# Modified AB-2 SHEAR PLATE Record of Design Change

03/25/2008

# Background

New 3 Puck from PPPL  
(with J weld preps)

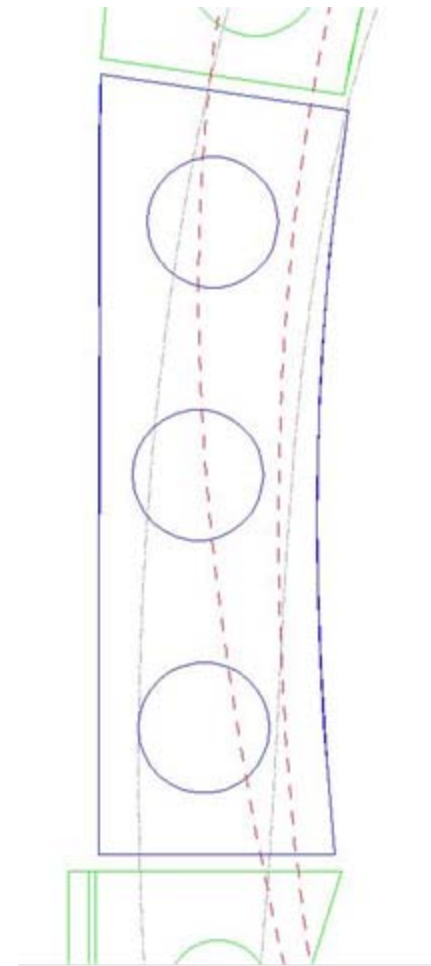
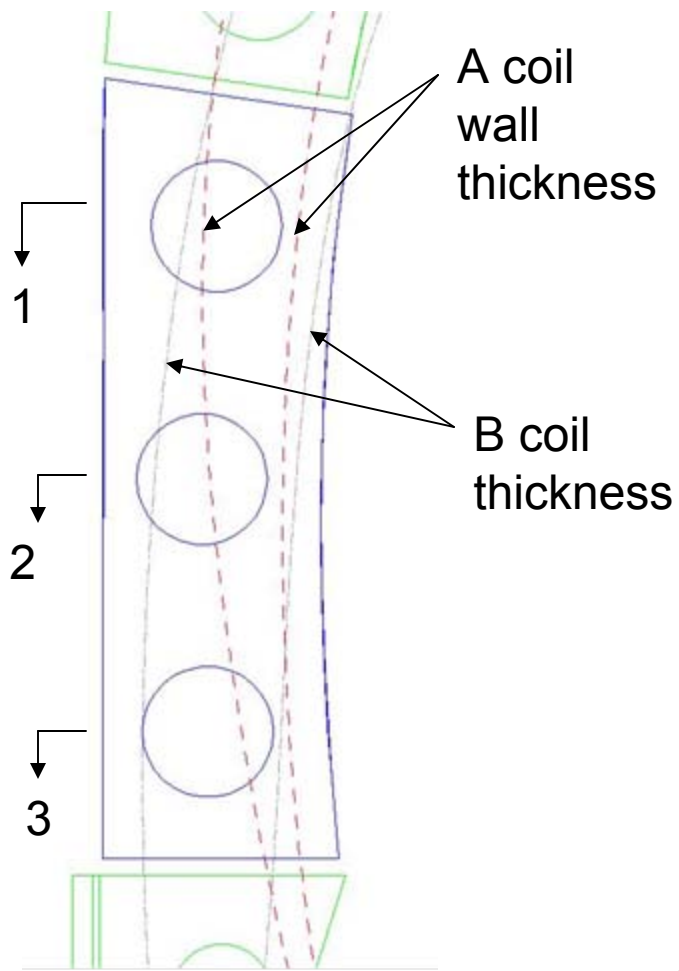
- Mike Viola requested that the weld for plate AB-2 be changed to a J prep type to improve welding (ie, avoid weld drop-out in open overhead welds in former overhanging fillet configuration).
- The revised plate is narrower, decreasing margin to puck holes.
- Originally a 4 hole, 1.5” puck diameter was planned to address hole margin, and dxf files were made of this.
- A shop mis-communication resulted in a modified 3-hole shim plate being manufactured.
- It was decided to perform stress analyses to determine if this modified 3 hole plate could be used.
- Analyses indicated this design is as good as the 4 hole, and consequently was adopted. **This document shall serve as the document of record of that change.**

Actual  
puck shift  
is .44"  
outward

# Weld stress, modified 3 puck AB-2

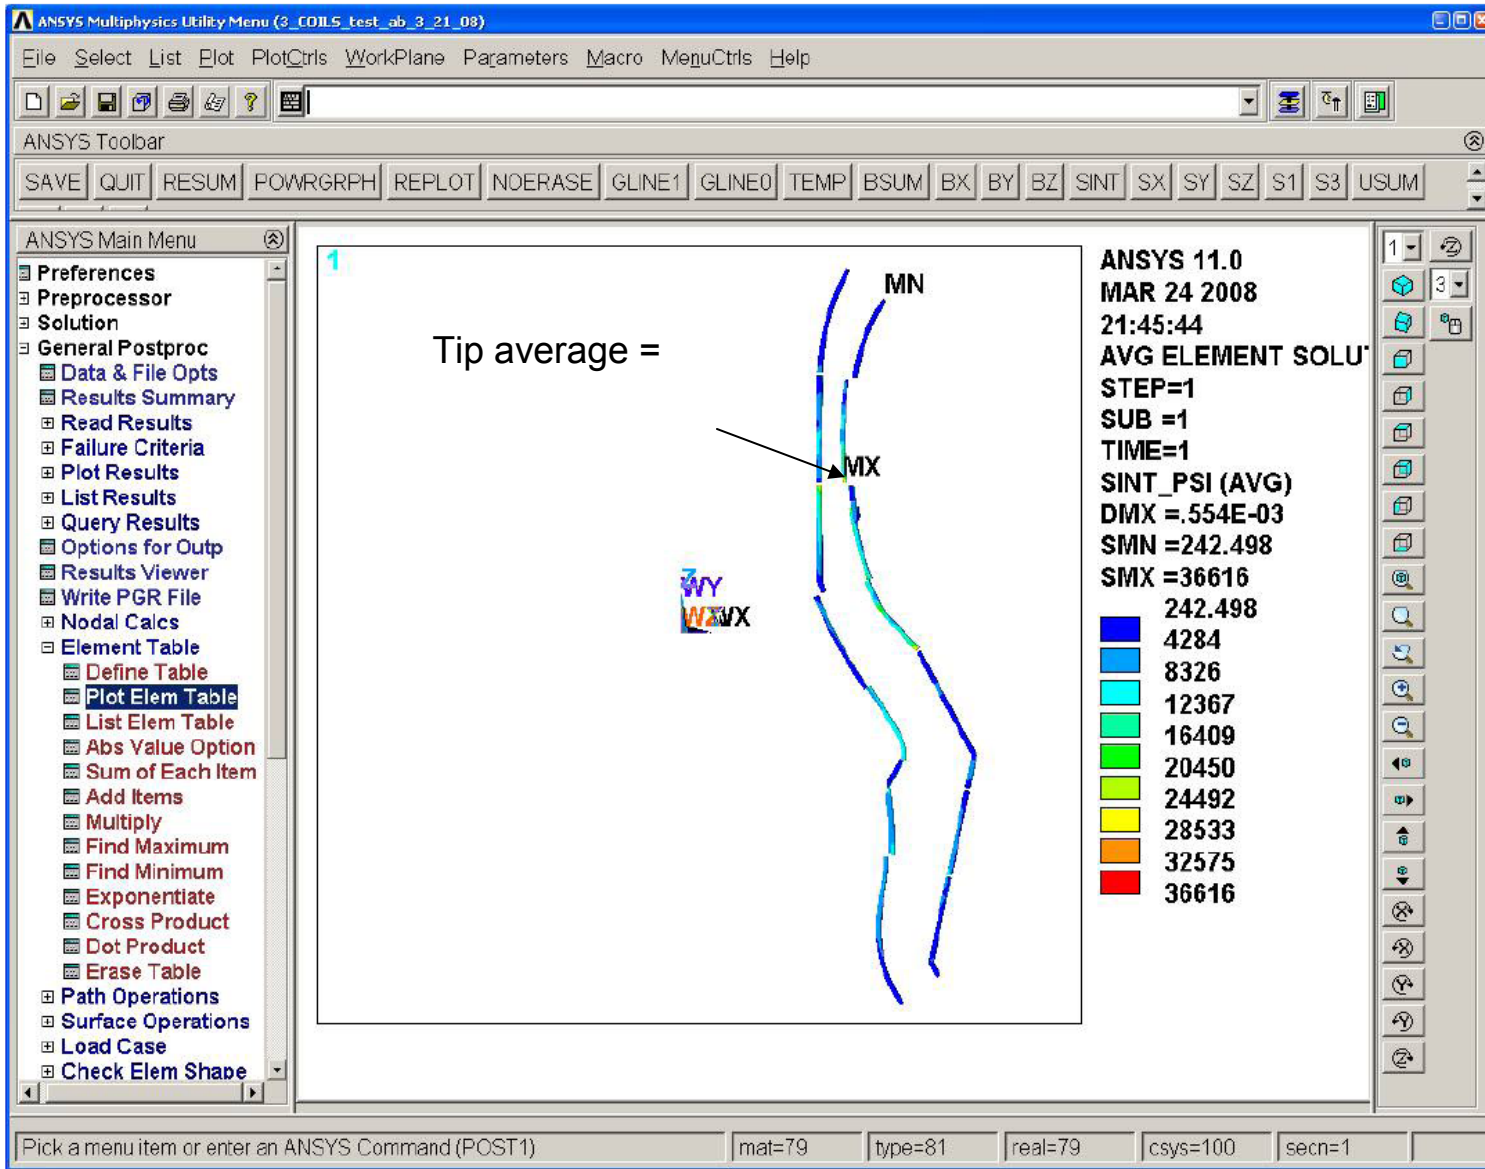
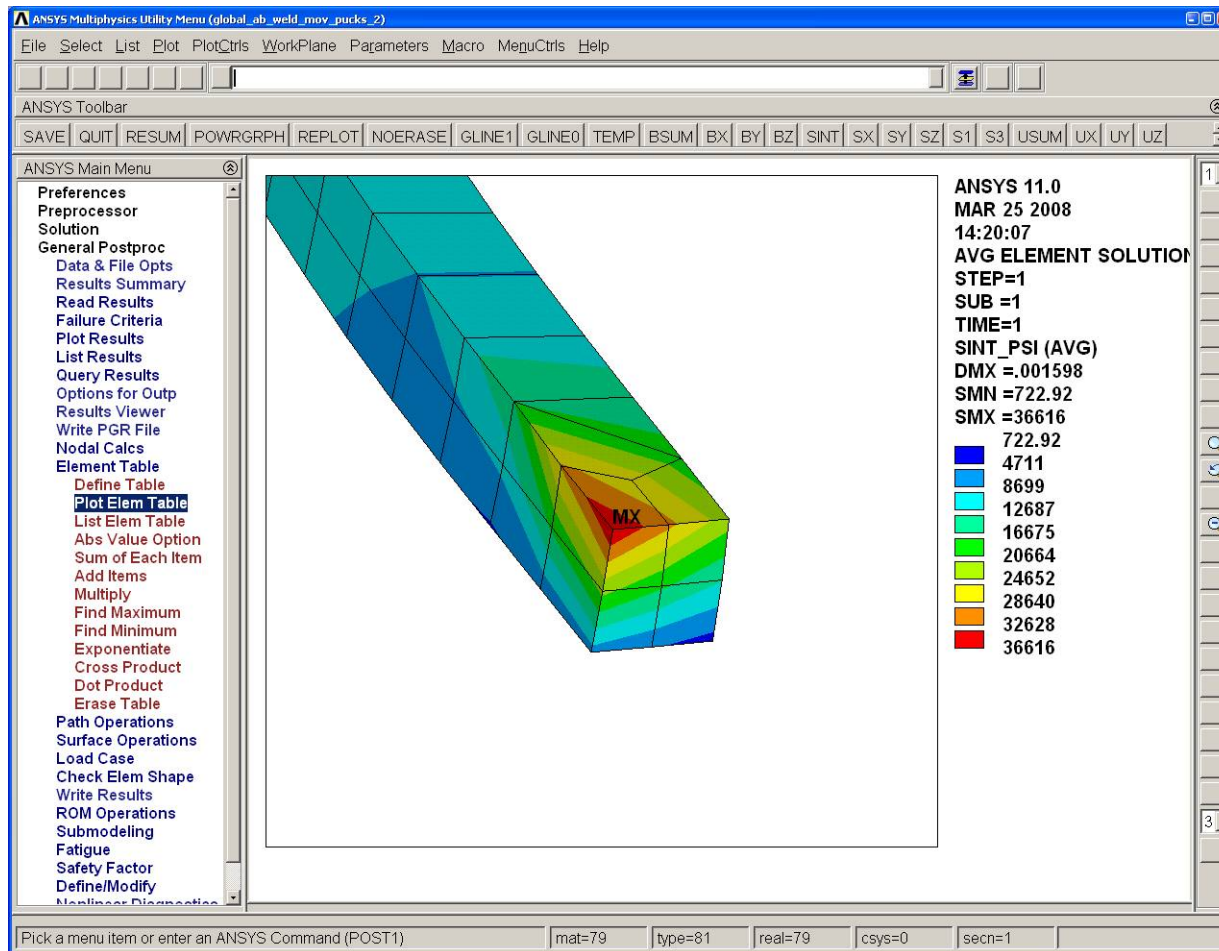
Stress on pucks does go up to 27.7 ksi vs 26.7 with 4 pucks  
peak weld stress now at 36.6 ksi down from 38.4 ksi (same node at corner)  
peak shim stress now at 44.5 ksi down slightly from 4 (same corner node)

three hole as good as four puck concept, original overhead weld was better.

- Modeled as Square welds,  $\frac{1}{2} \times \frac{1}{2}$ ".

# Close up view of shim

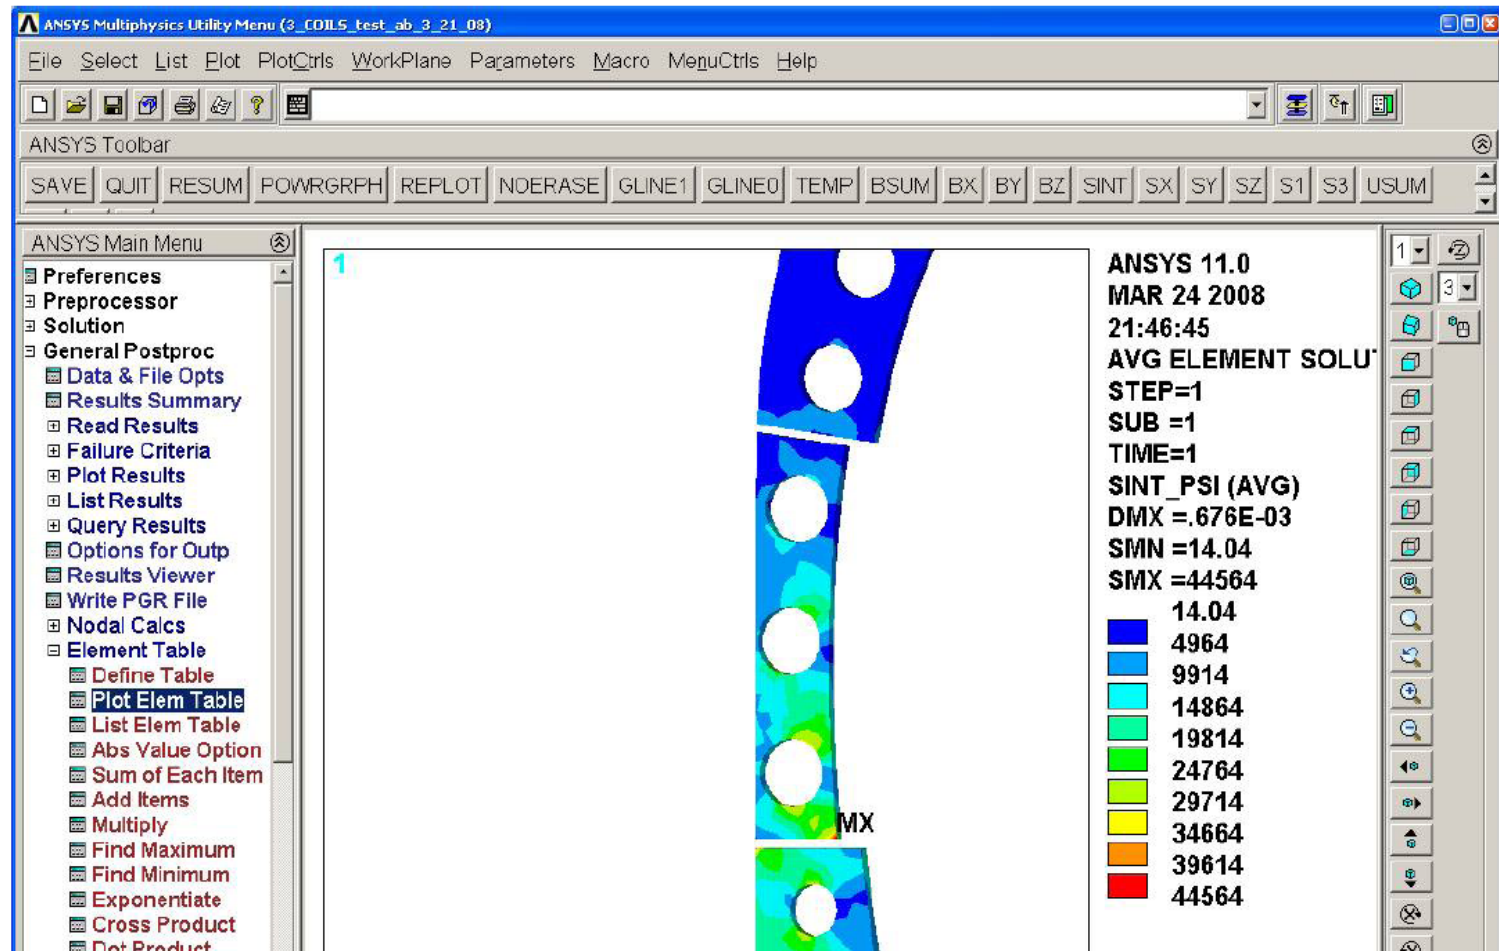
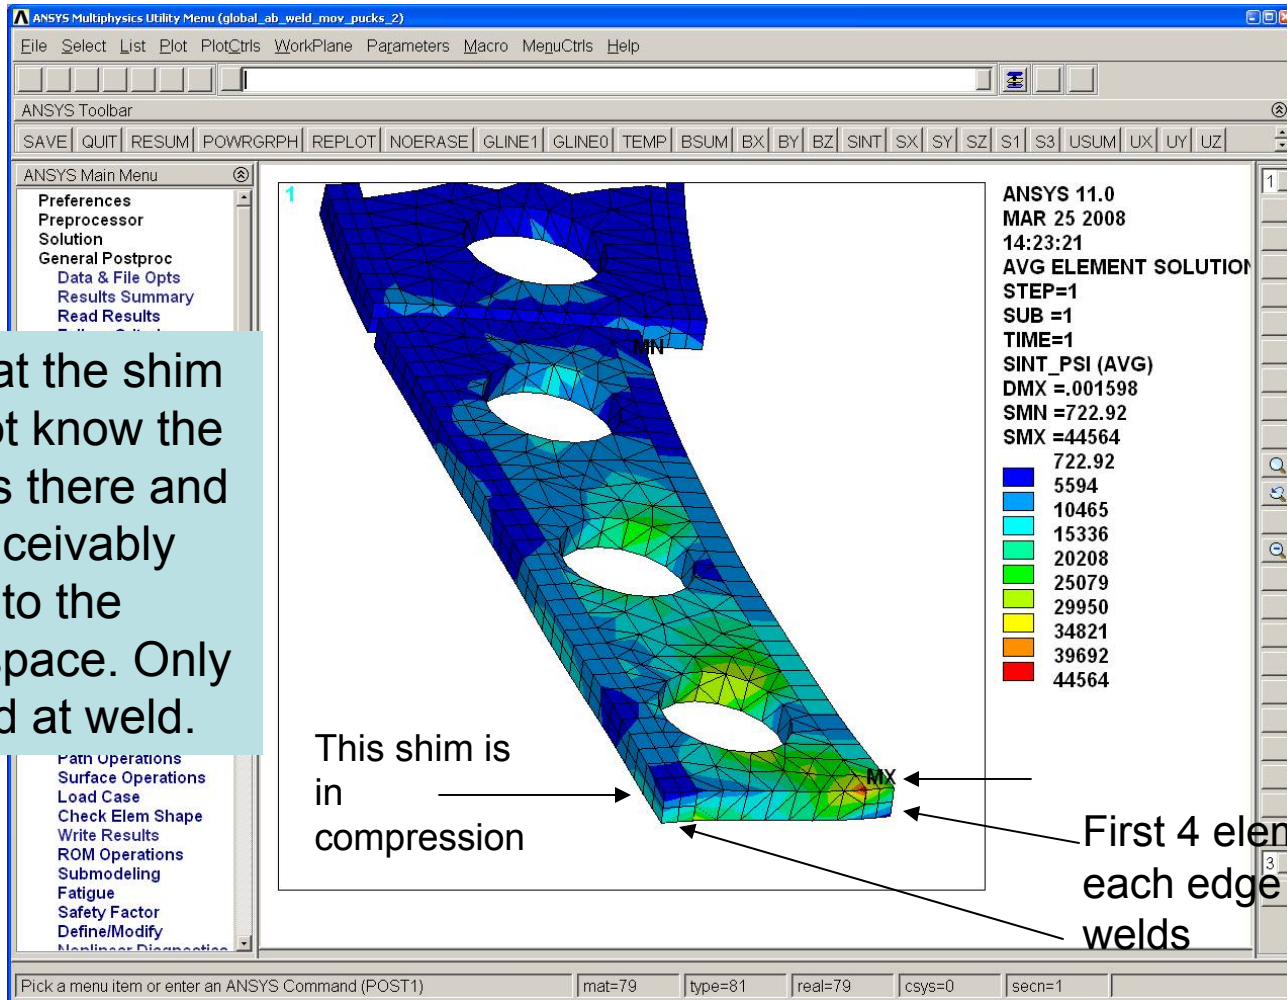
Note that the shim does not know the flange is there and can conceivably move into the flange space. Only attached at weld.
